Doc. No. BECO/ESR-1
SEPTEMBER 1984
REV. 1

Detailed Control Room Design Review

Executive Summary Report

Pilgrim Station

FIGURE 3-4.
 REACTOR FEED PUMP AND
 CIRCULATING WATER CONTROLS

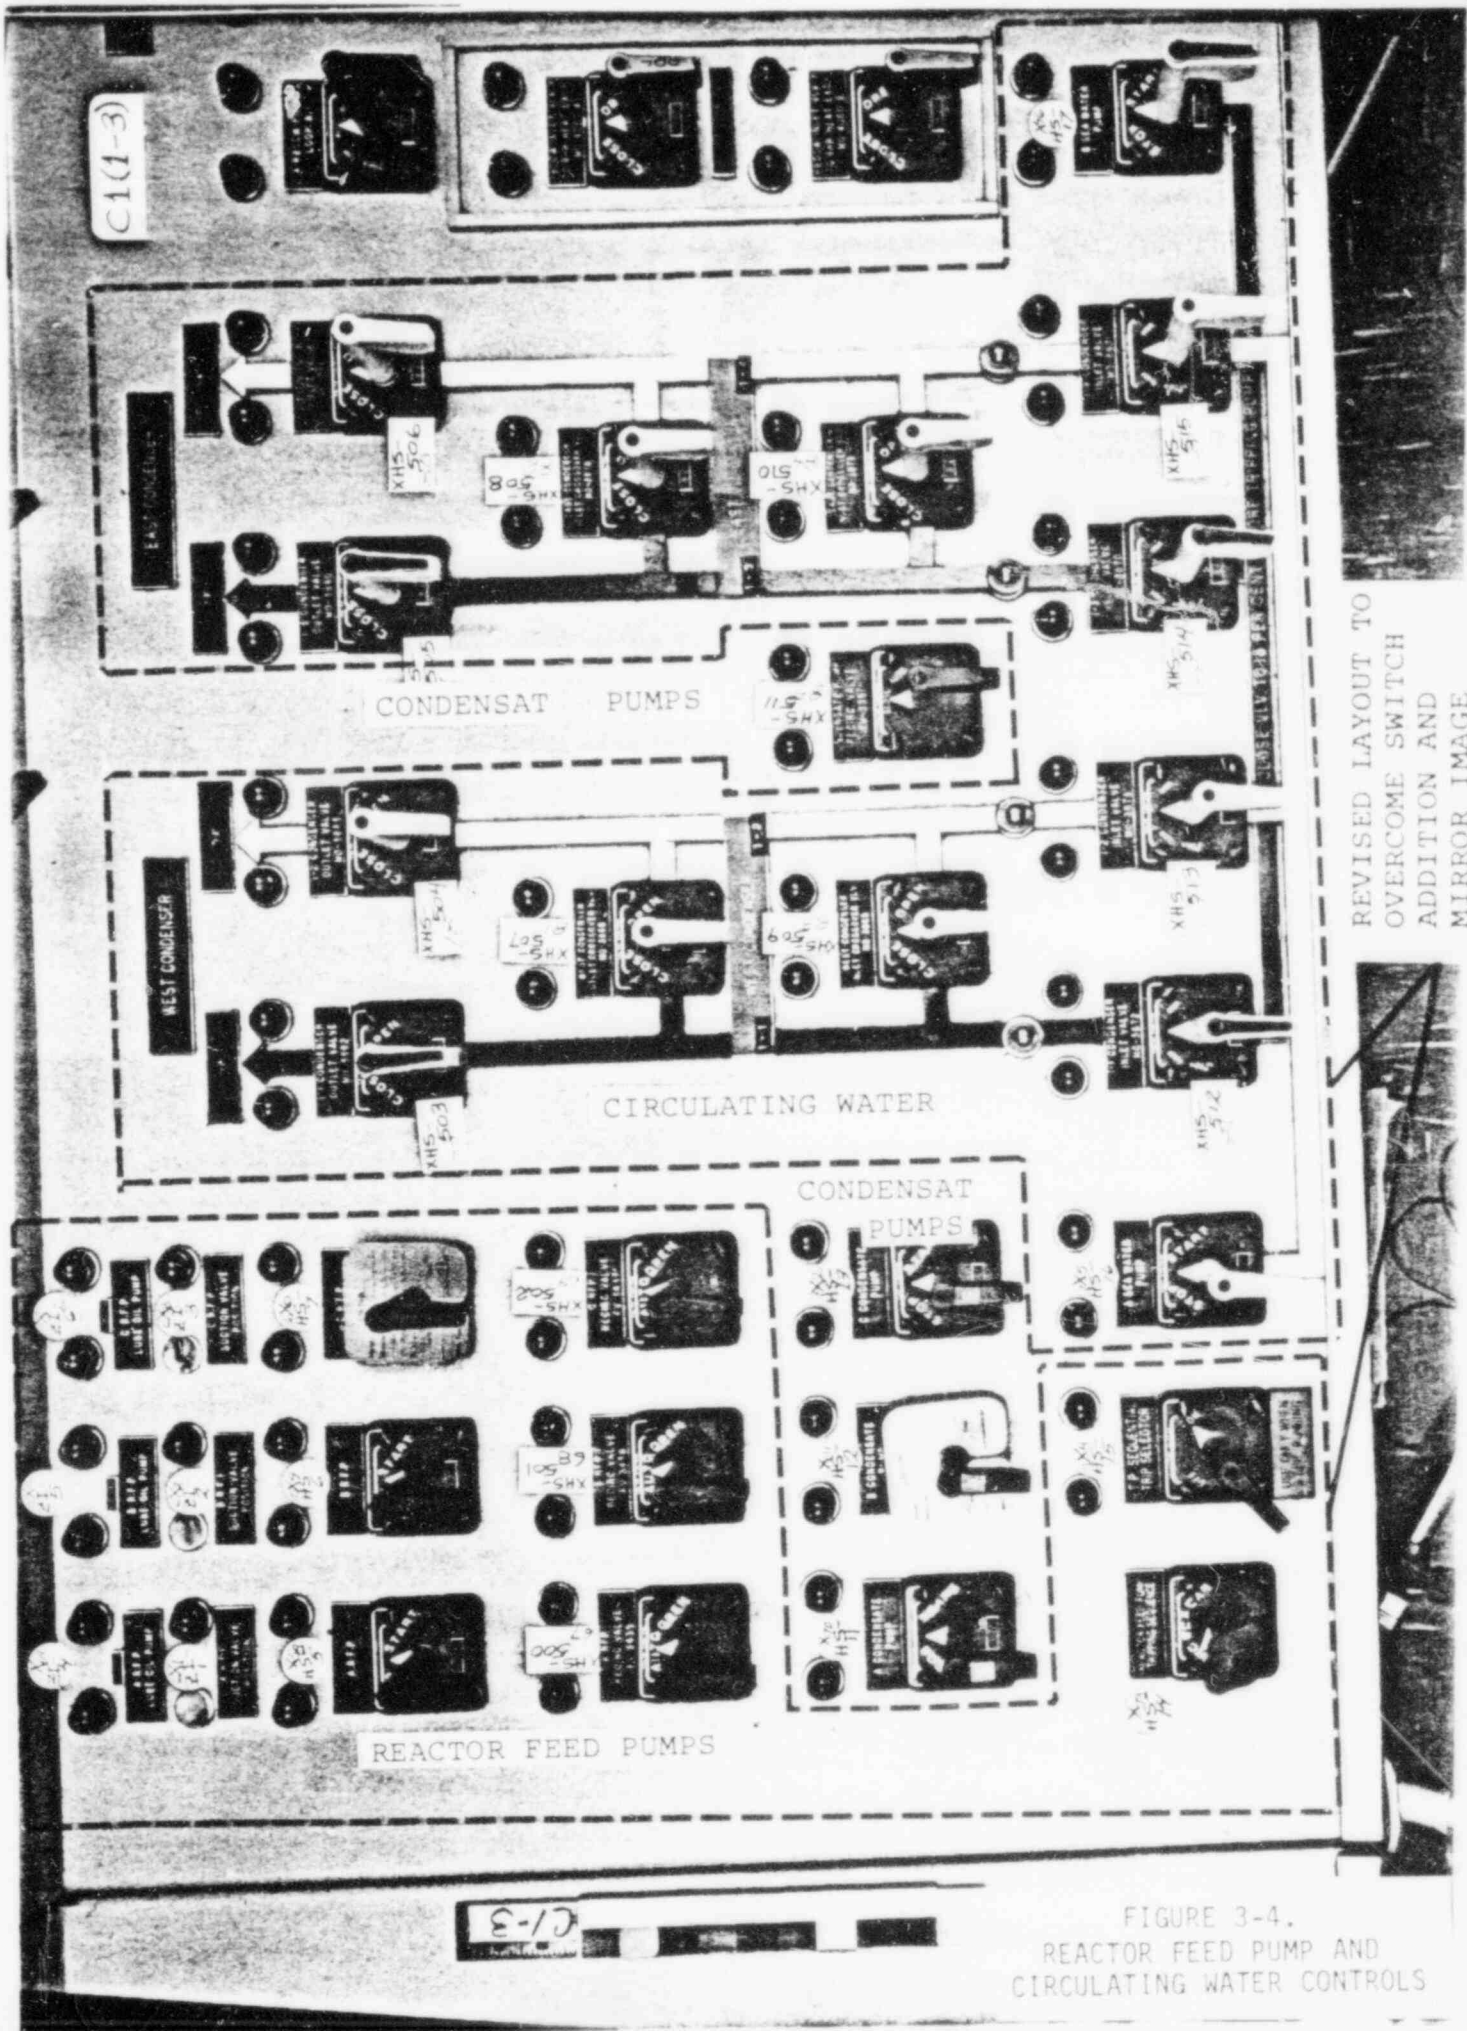
Figure 3-4 shows the control equipment for the reactor feed pumps as it presently is. Included is a brief description of the change brought on by the addition of the Auto Trip (43/TCOS) switch relocated to this area by HED 4B126.5. The switch cannot be added to the panel without moving something else because there is no room to put it near the RFP controls. To put it anywhere else would not resolve the reported discrepancy. The layout of the RFP controls will need to be revised in order to fit the switch in. Figure 3-5 is the proposed Reactor Feed Pump (RFP) arrangement. The valve controls have been changed to a smaller switch so that the arrangement will meet minimum switch separation requirements. Smaller RFP ammeters have been incorporated into the layout. This will increase operator comprehension and make the total required panel area about the same.

The revised reactor feed pump arrangement creates a domino effect on the arrangements for the condensate pumps which in turn affects the arrangement for the circulating water system. Figure 3-4 shows the condensate pumps and circulating water system controls as they presently are. It also has a brief description of the change required.

FIGURE 3-6.
PROPOSED CIRCULATING WATER SYSTEM ARRANGEMENT

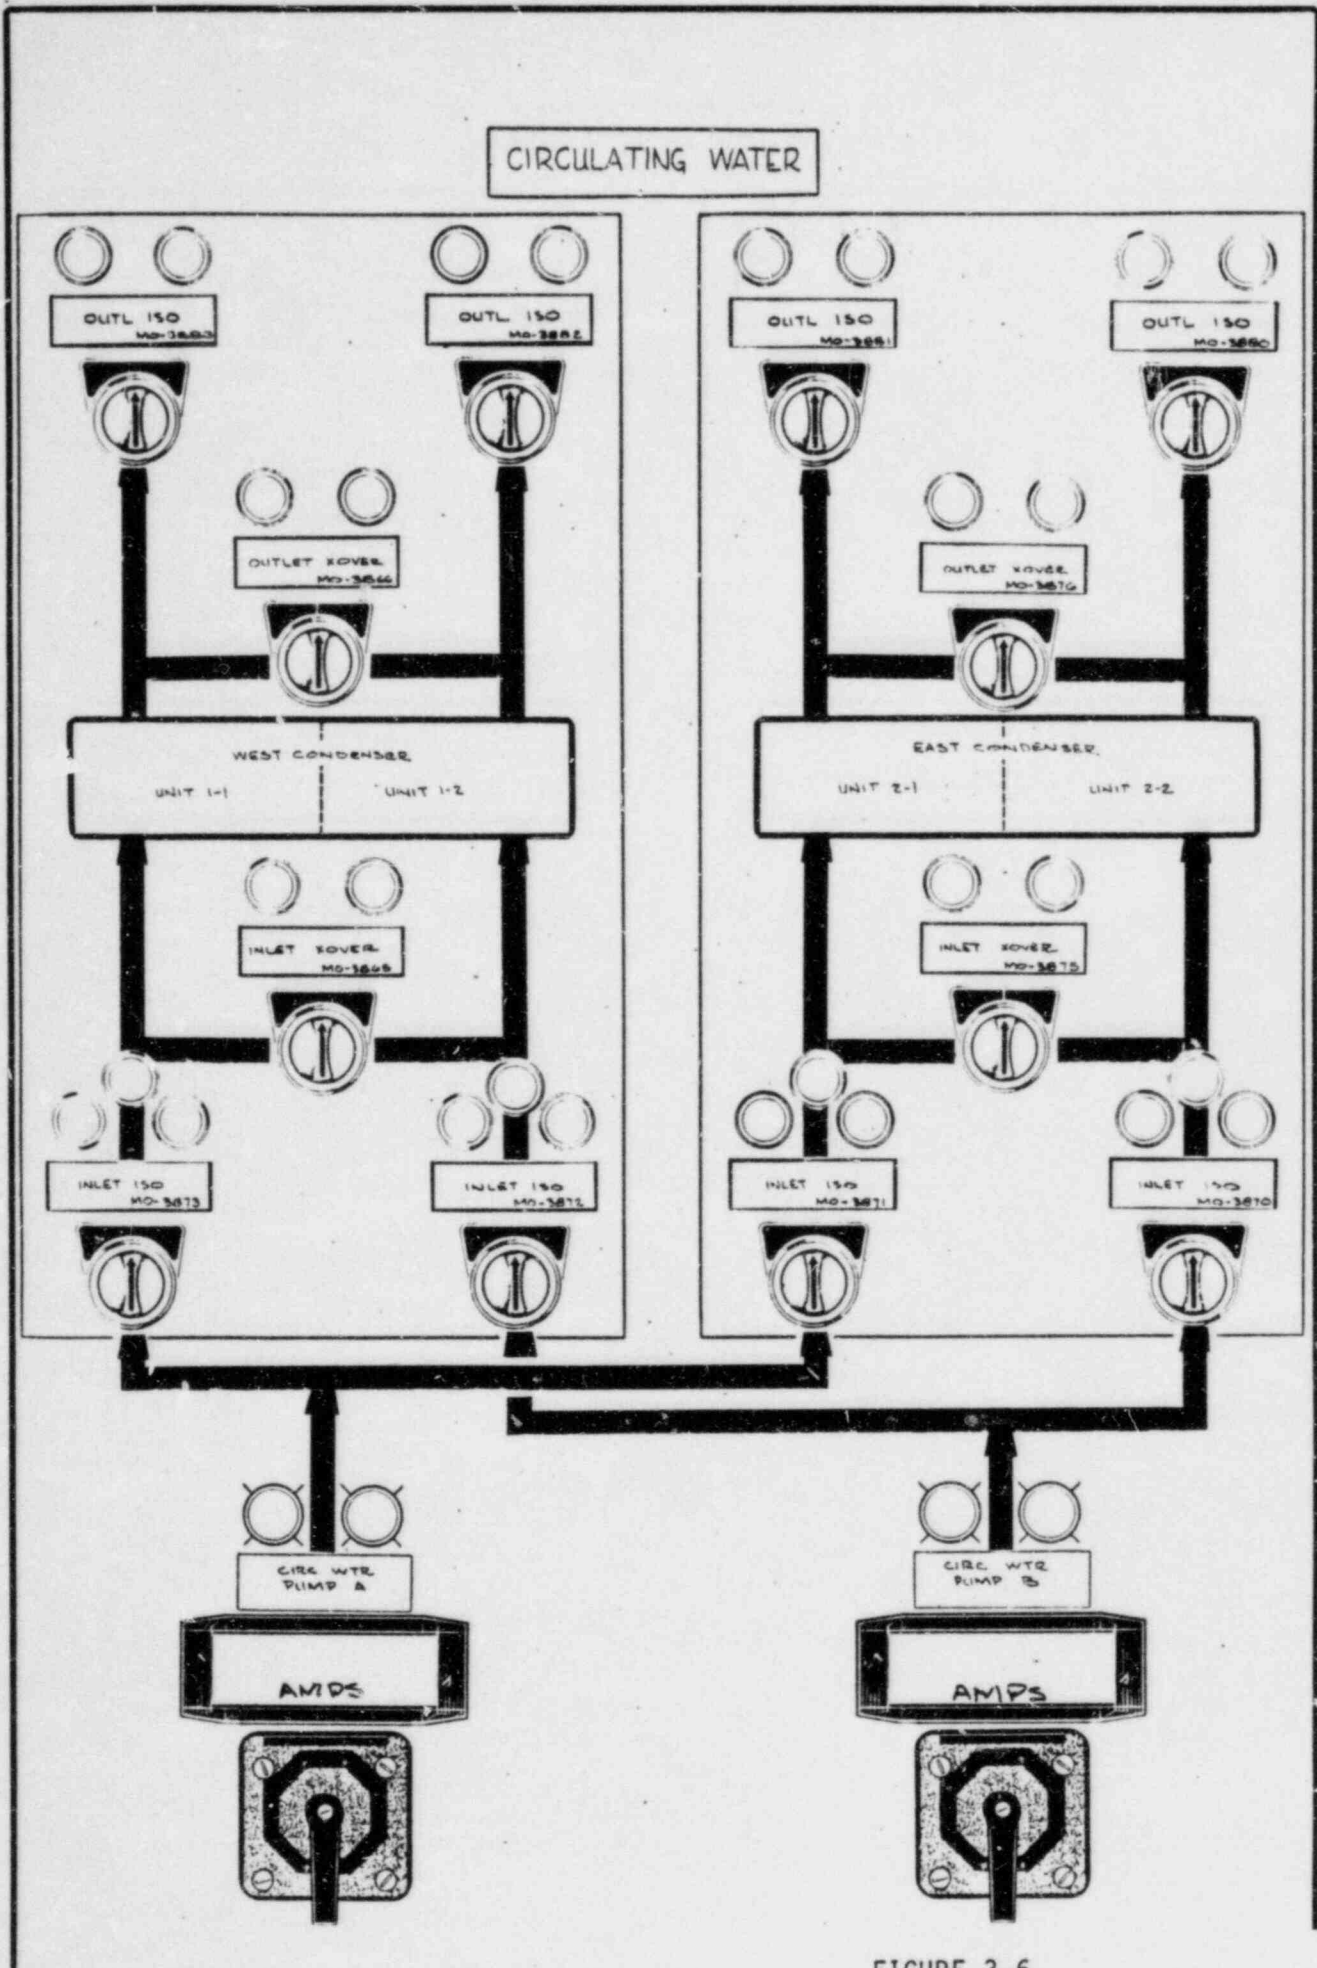
Figure 3-6 is the proposed circulating water system arrangement. The value controls have been changed to a smaller switch so that the arrangement will meet minimum switch separation requirements and still occupy about the same area.

HED 4B126.5 requires that the reactor feed pump auto trip switch be relocated to the Feedwater and Condensate panel C1 in the close proximity to the reactor feed pump controls. See Figure 3-6 for the new proposed layout.

FIGURE 3-8.
RBCCW AND TBCCW CONTROL

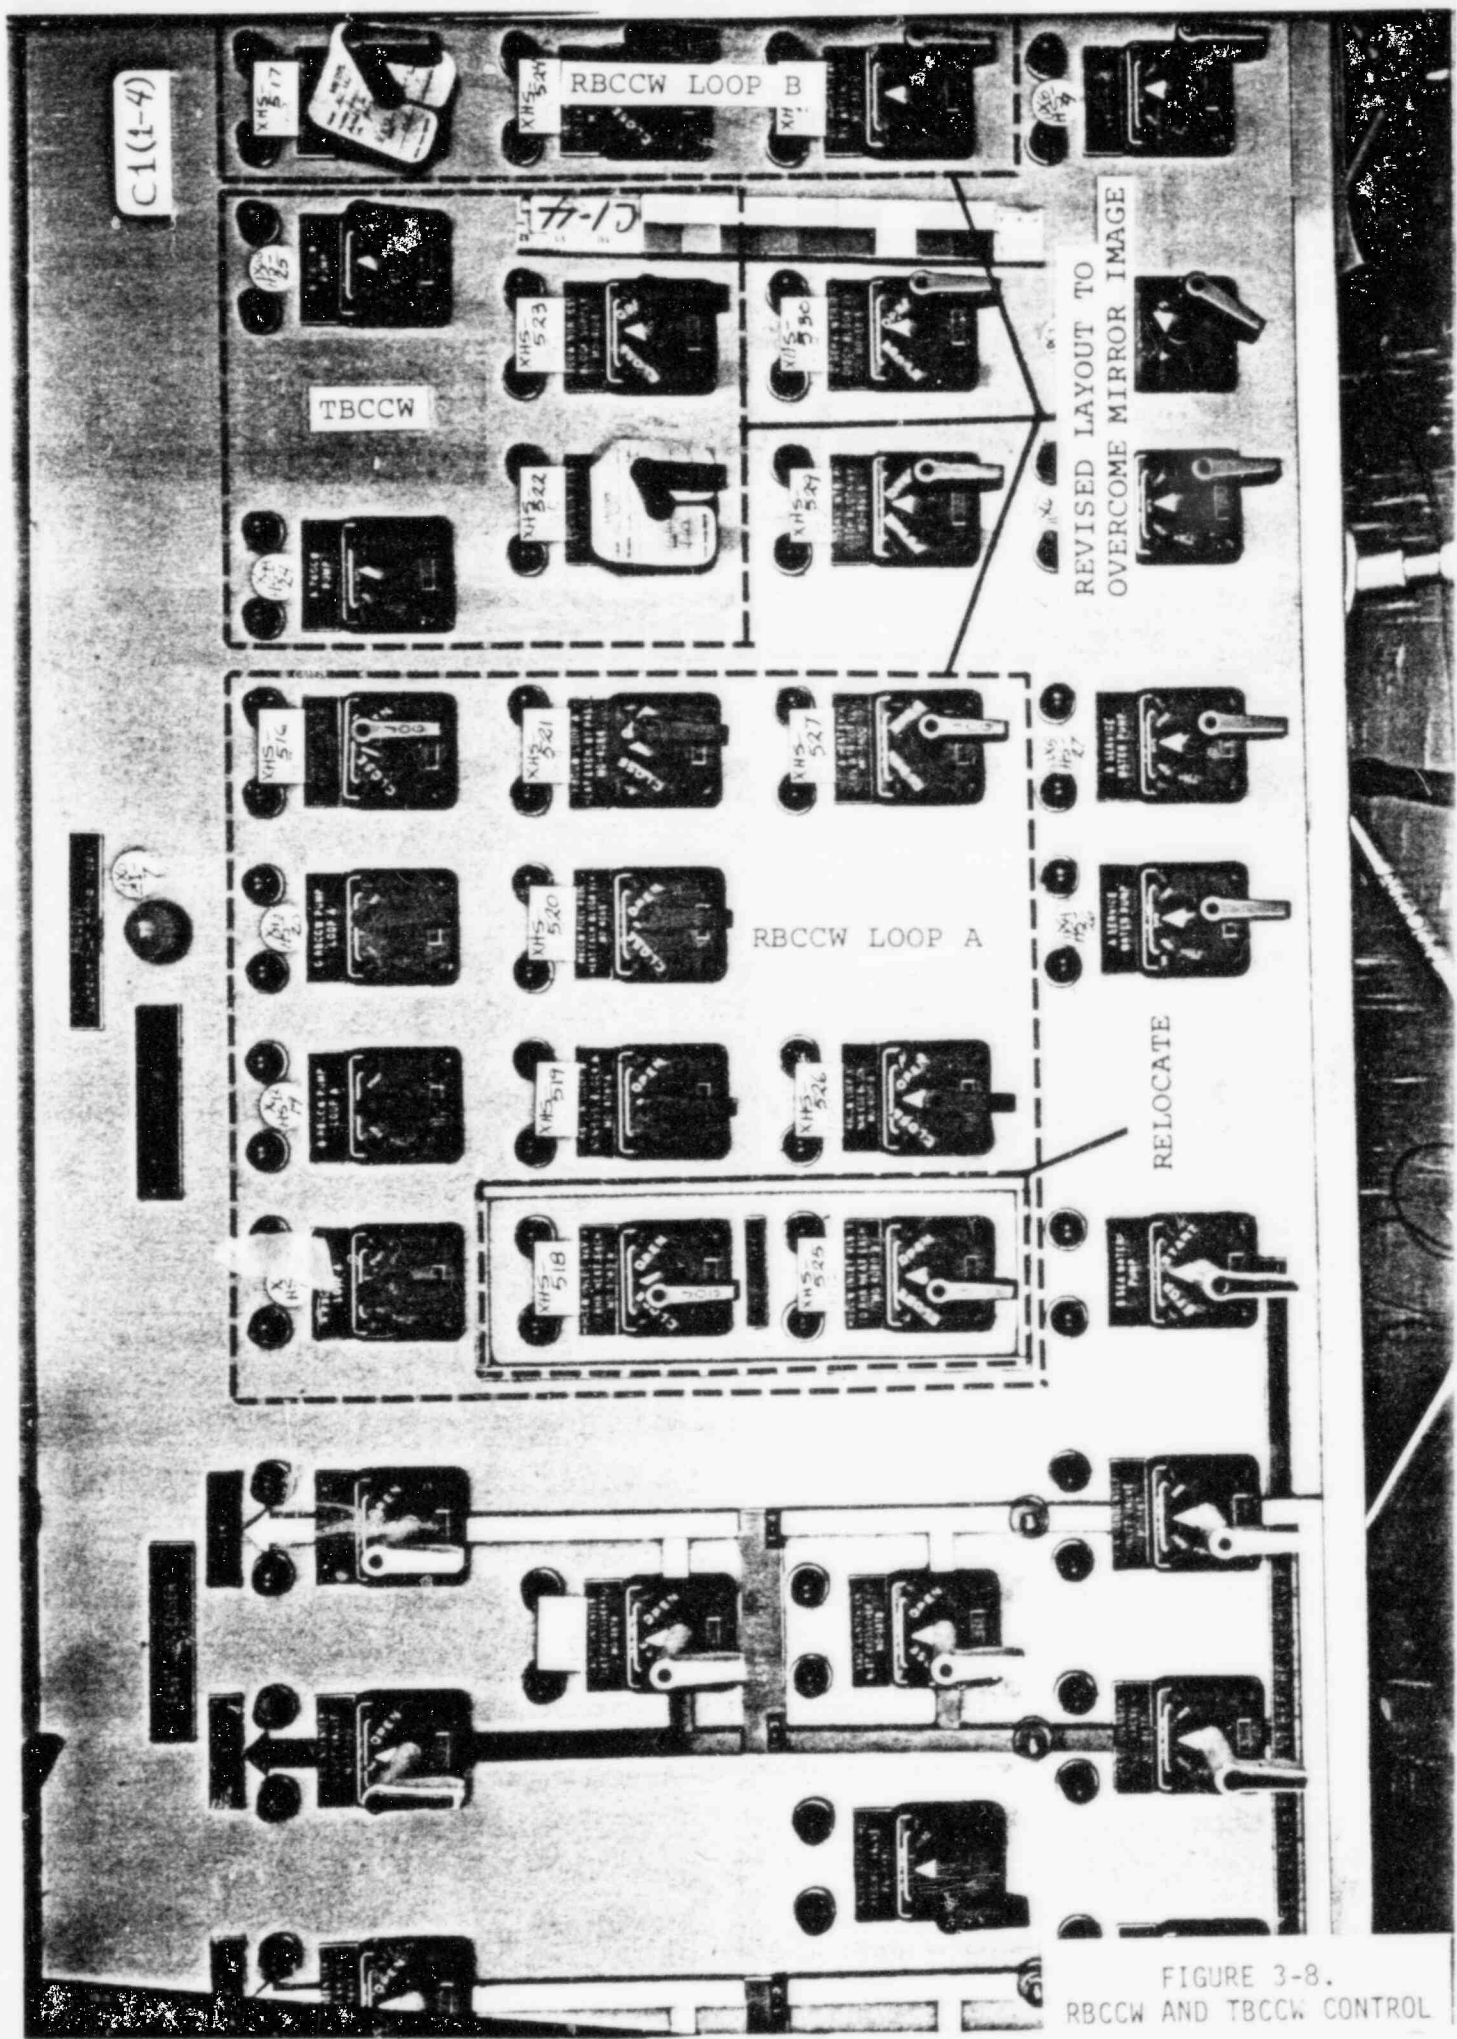
The Reactor Building Cooling Water (RBCCW), Turbine Building Cooling Water (TBCCW), and Service Water (SW) systems are interrelated. Figures 3-8 and 3-9 show the present systems arrangement and give a brief description to the proposed solution to the mirror image problem described in HEDs 4B053.5 and 8B097.5.

FIGURE 3-9.
RBCCW LOOP B CONTROL

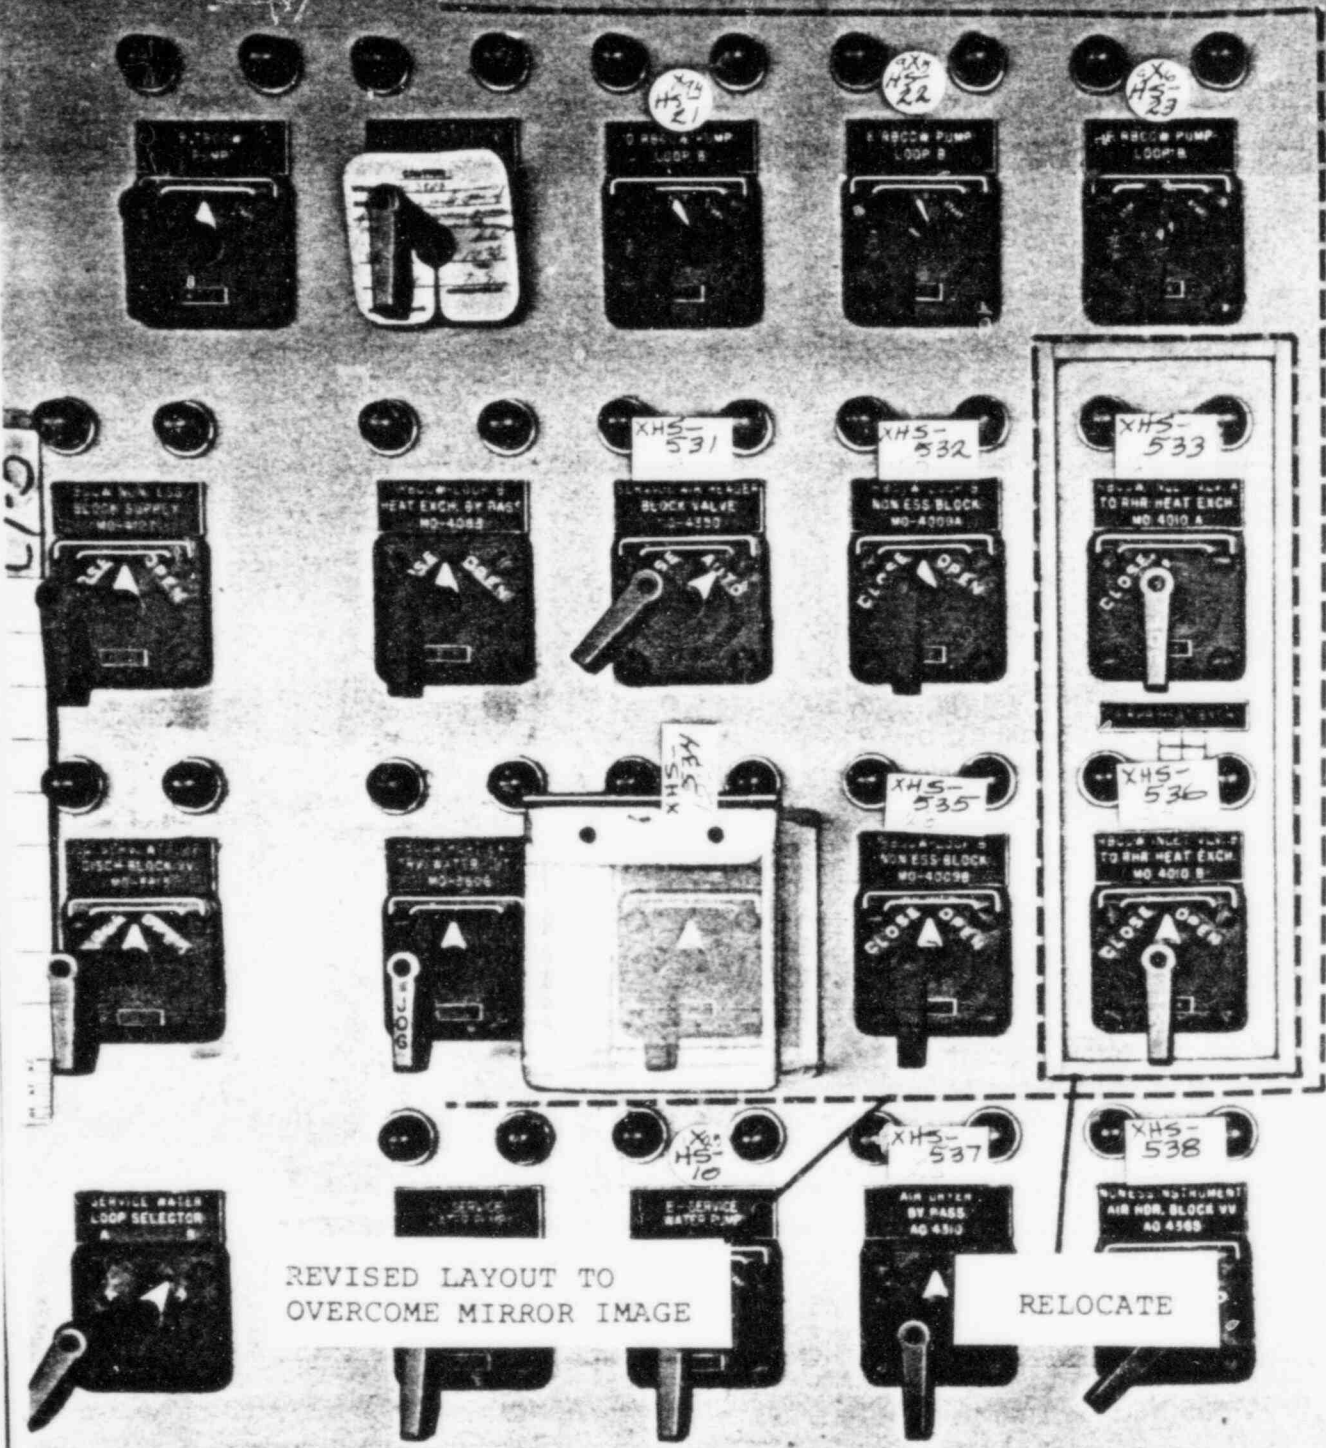
REVISED LAYOUT TO
OVERCOME MIRROR IMAGE
